OXNARD SCHOOL DISTRICT

1051 South "A" Street • Oxnard, California 93030 • 805/385-1501

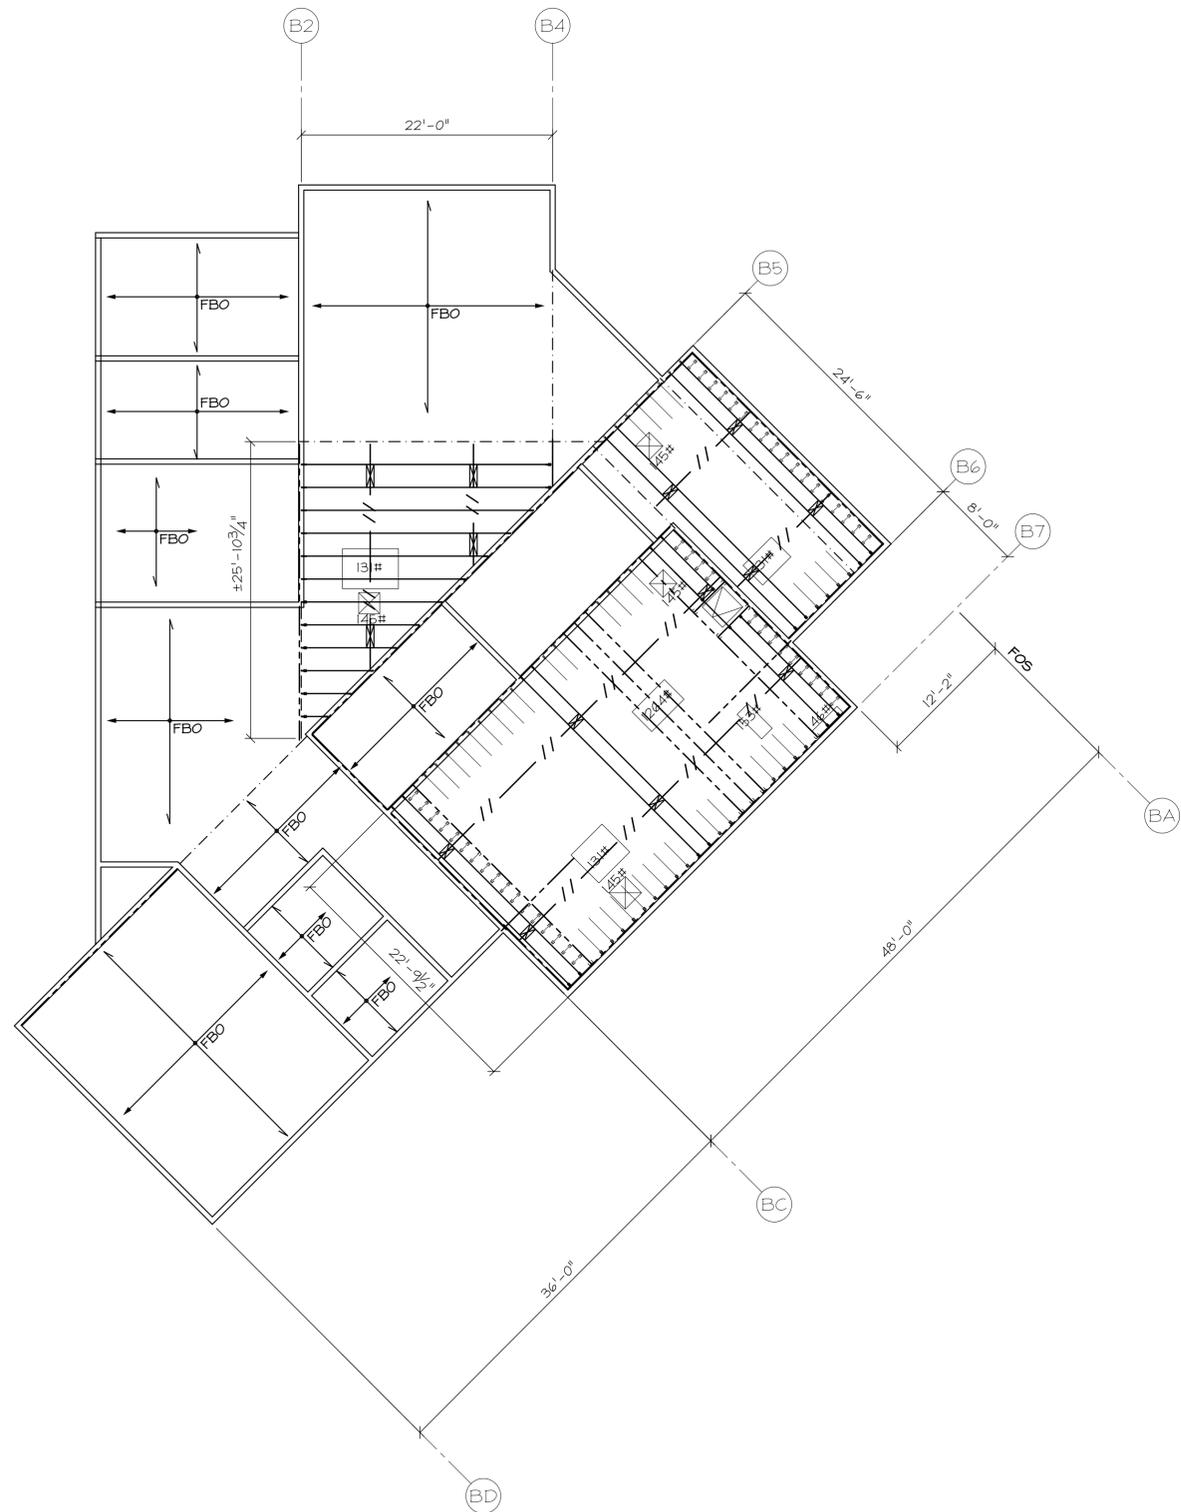
EOR: Please submit the attached package including roof location plans, detail and calculations per the DSA request to comply with RFI 172 and indicate if RedBuilt should proceed.

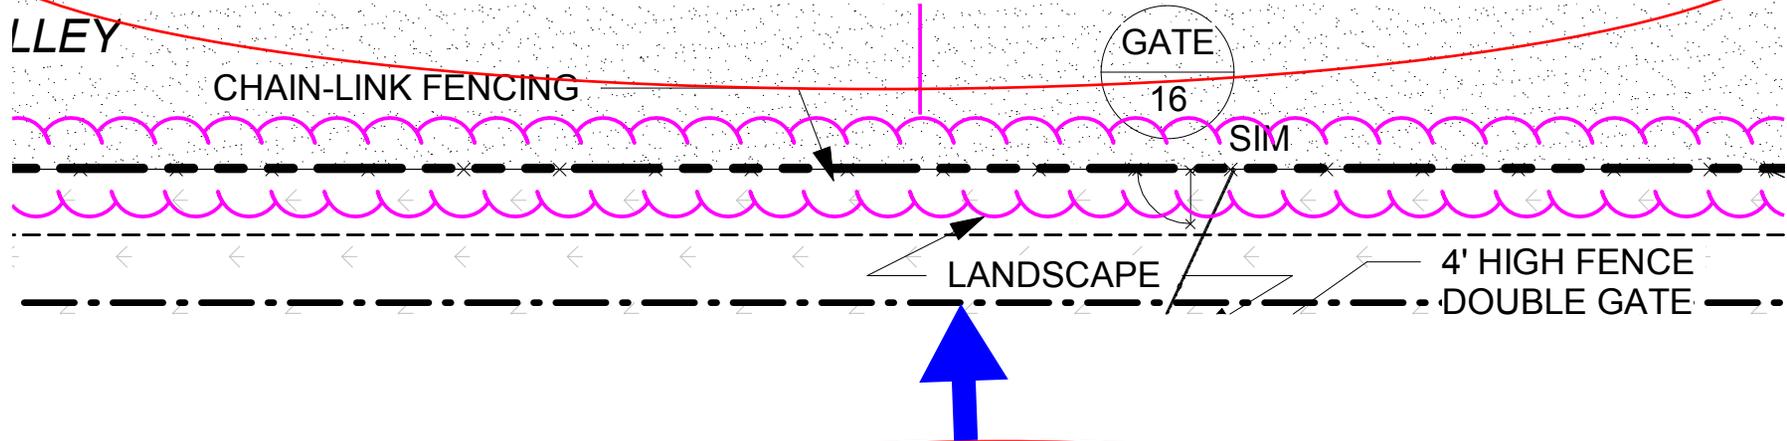
Please review and advise Bernards, **WITHIN 7 days**, if there are any additional costs or schedule impacts associated with incorporating the RFI response with the Contract Work. (Include a brief description and rough order estimate of the change with this notification. If no response is received within 7 days, Bernards shall trust that there is no impact to your Contract Price or Schedule.

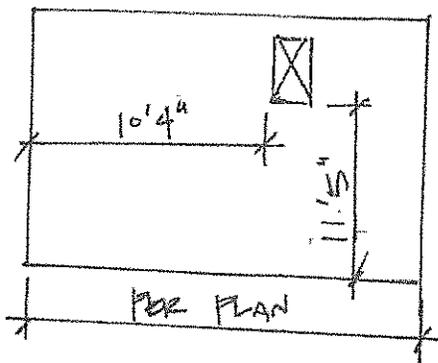
NC Response:

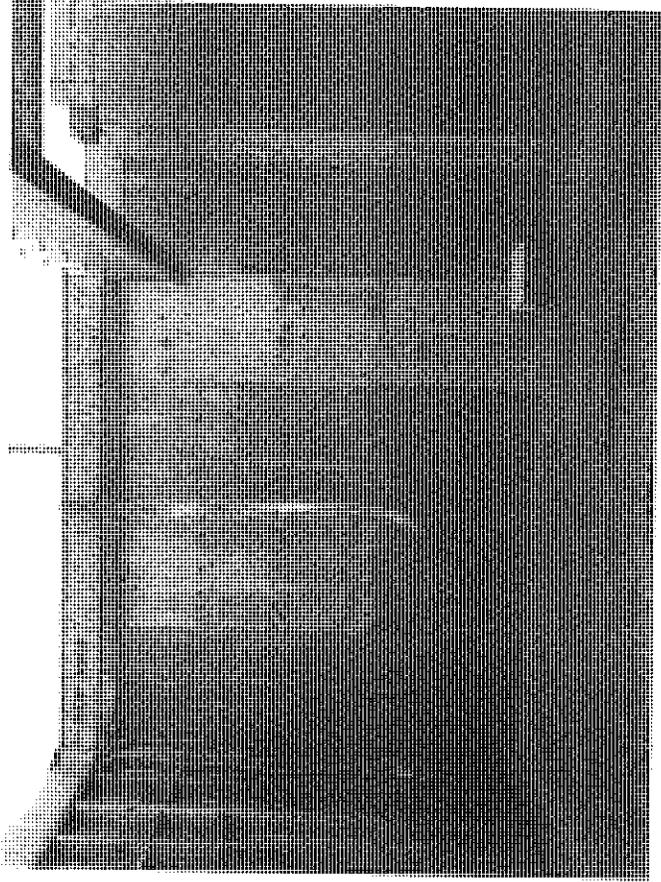
NC Additional Clarification:

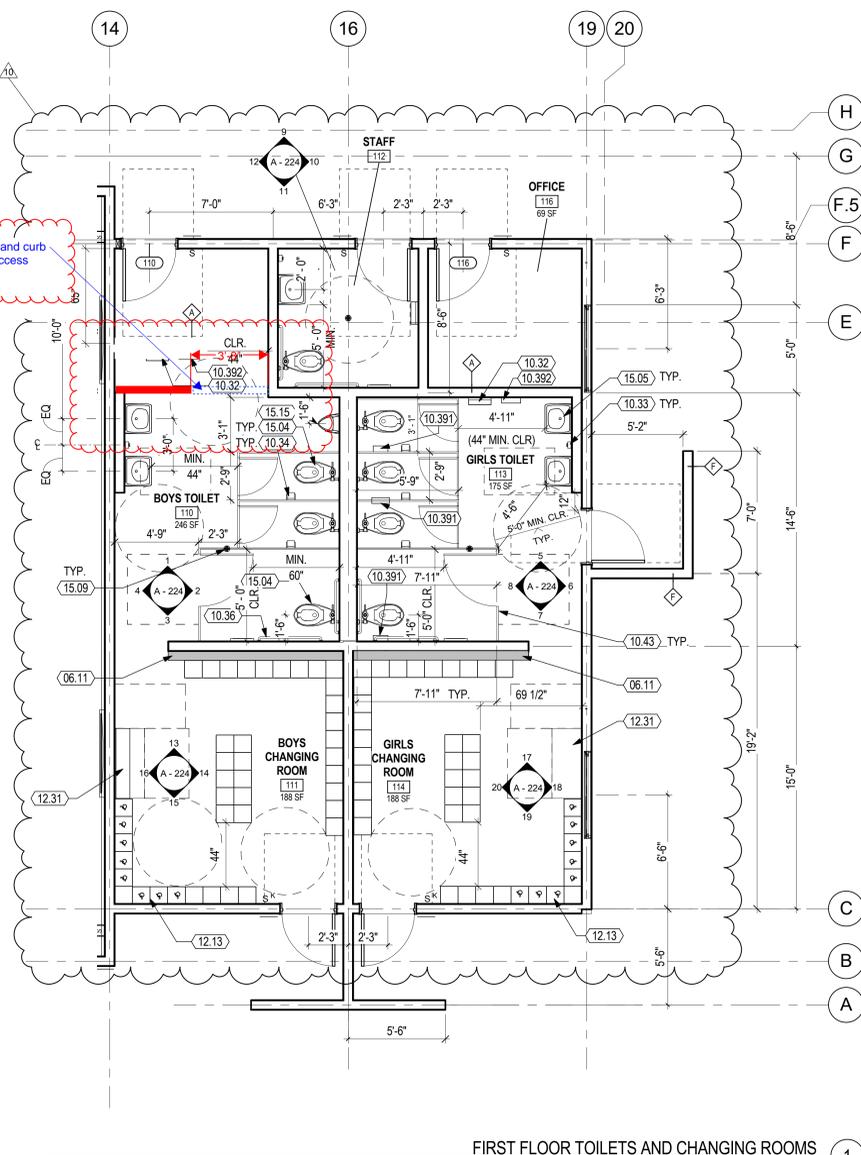
REFERENCE RFI 290, USE FOR RESTROOMS LAYOUT.

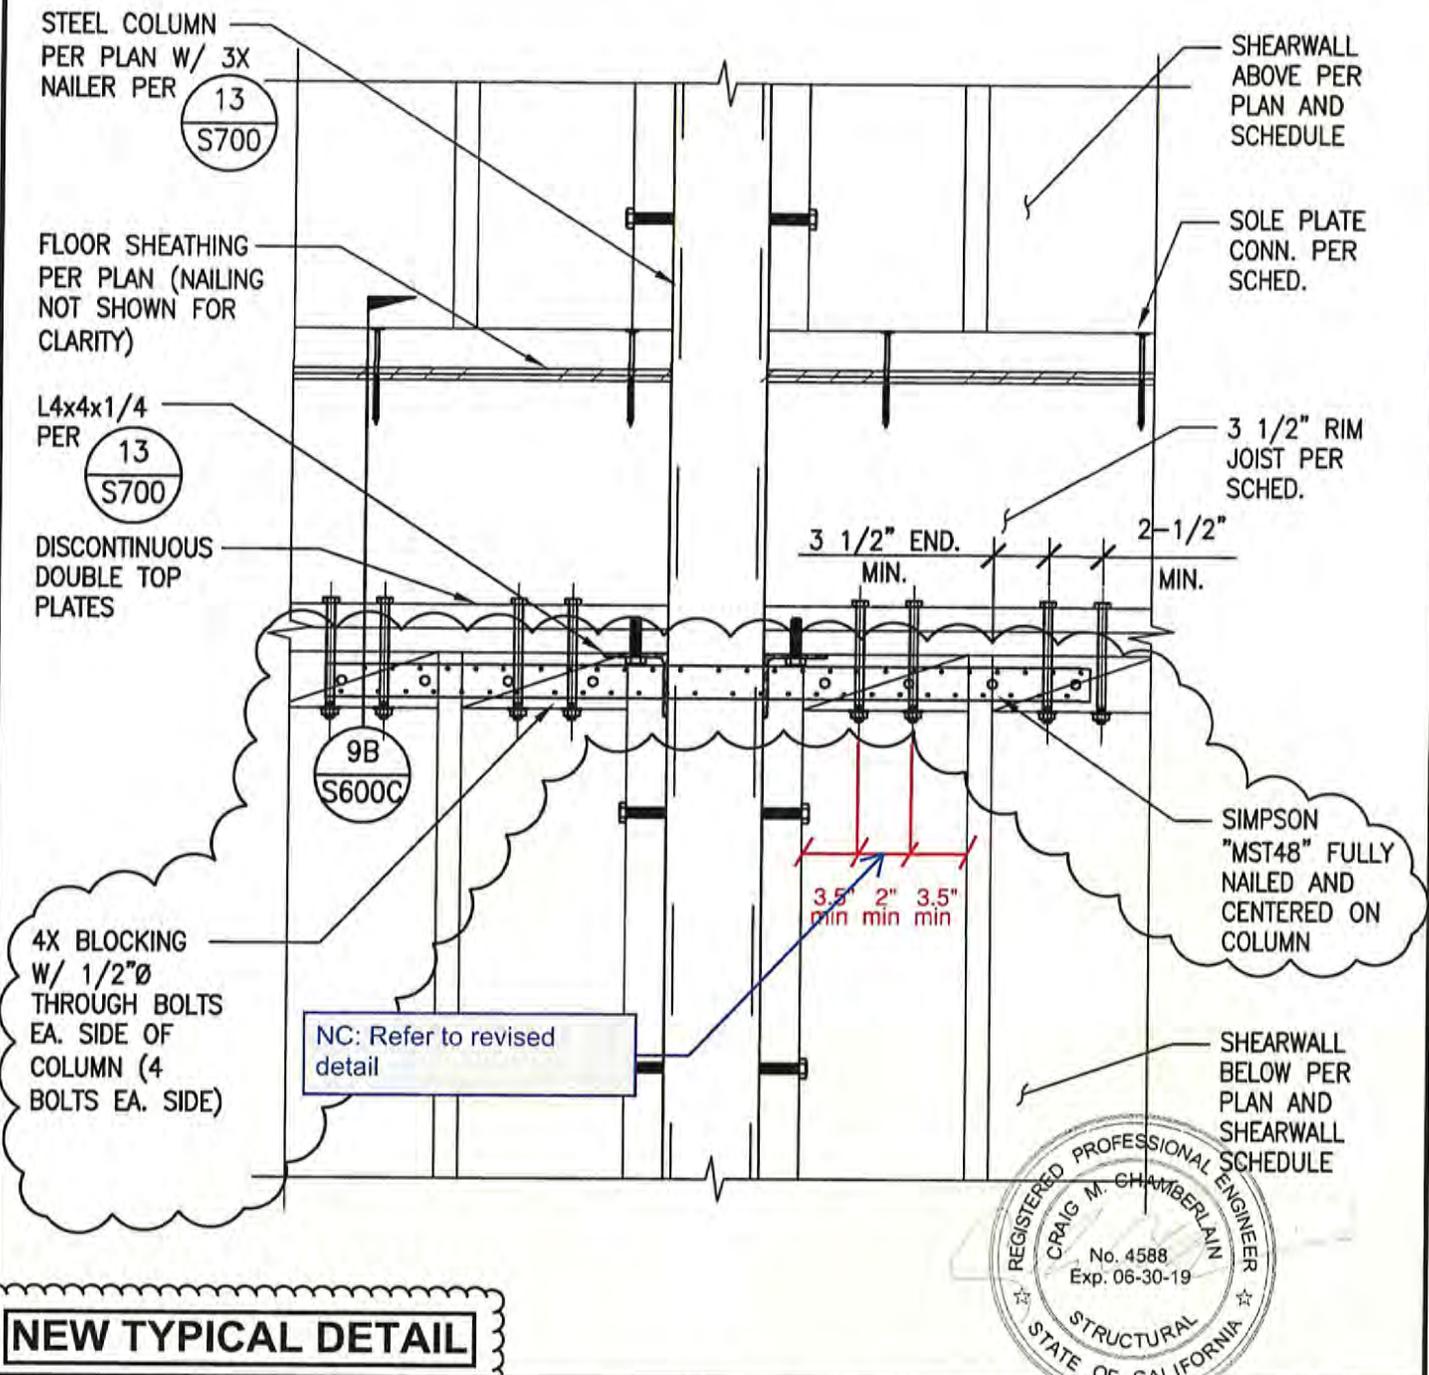
Structural comments:

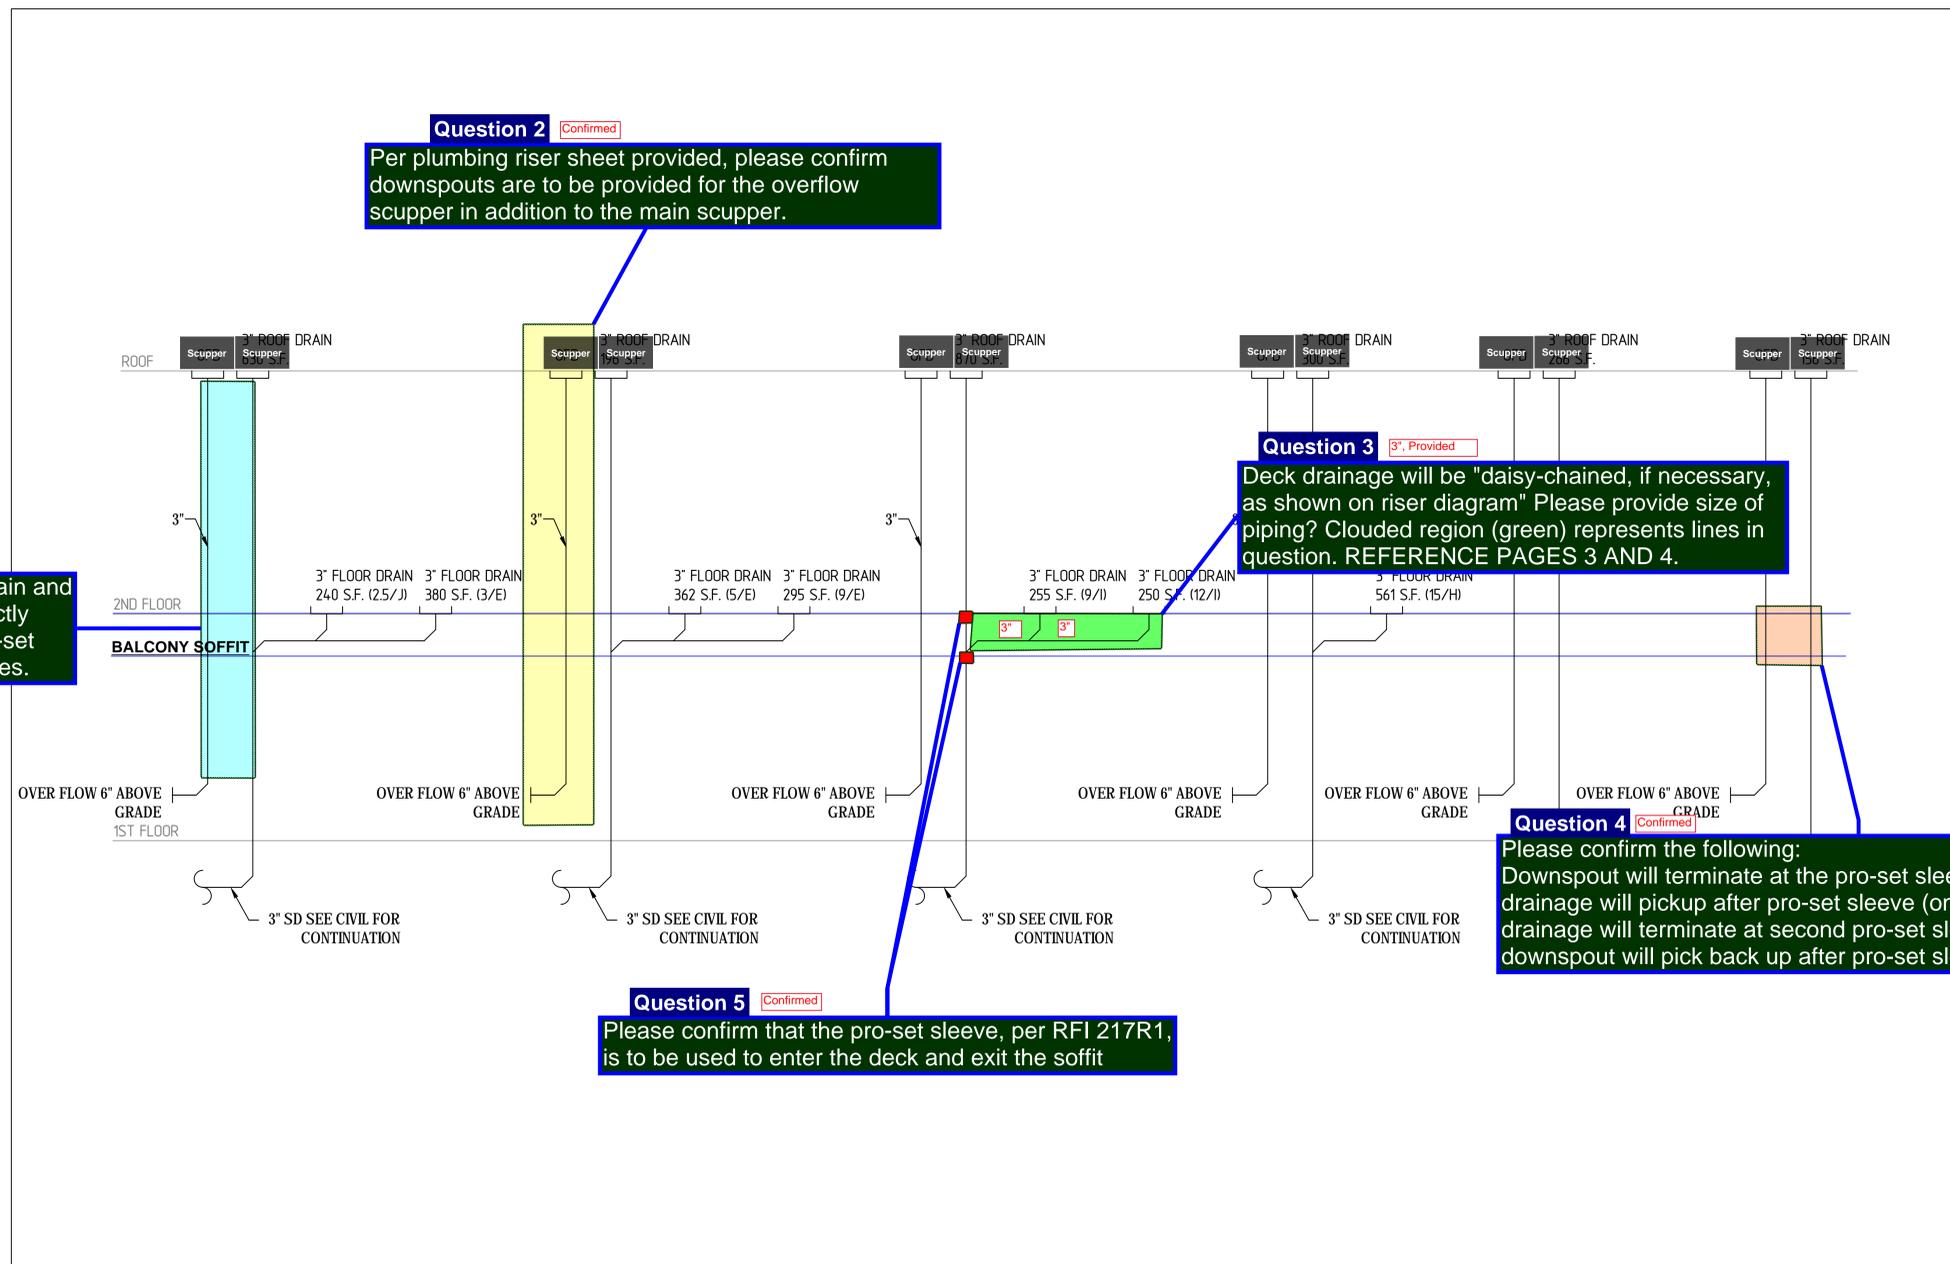
Question 1 Confirmed
Please confirm all downspout piping (main and overflow), and all deck drain piping directly connected to downspouts using the pro-set sleeve (RFI 217R1 response), are 3" lines.
